## City of Campbell

**This is a sample plan check template that will be used to review a new ADU application. It contains useful notes and explanations of requirements for design drawings.**

Permit Application#: BLD2023-      Address:  
Scope of Project: New Accessory Dwelling Unit (ADU) (      sf)  
Occupancy: R-3    Type Bldg: VB    APN:

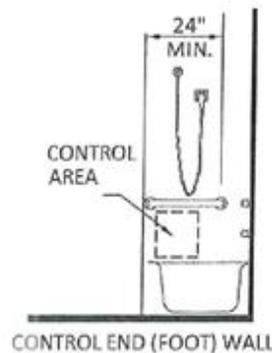
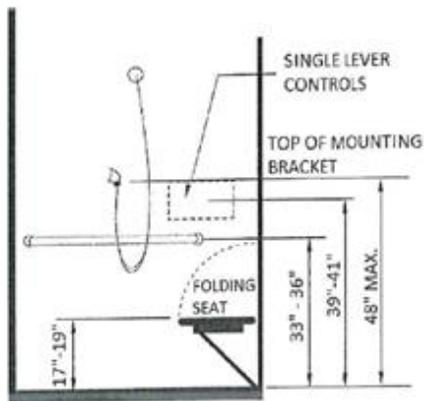
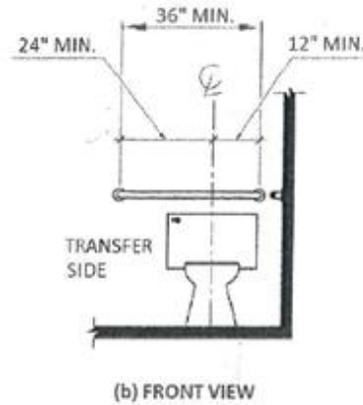
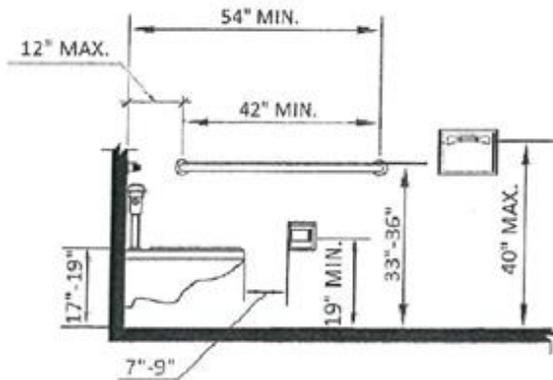
14. Obtain an approval letter from West Valley Sanitation District (408) 378-2407. This letter is often used as the sewer permit. If W.V.S.D. requires “check valve protection or a property line cleanout” on this project, mark the location on the site plan and the plumbing plan and place a boxed note: *West Valley Sanitation District (W.V.S.D) has required a check valve or a property line cleanout or both (only list exactly what they are requesting). The sewer line modification will require inspection from WVSD and the City of Campbell.*
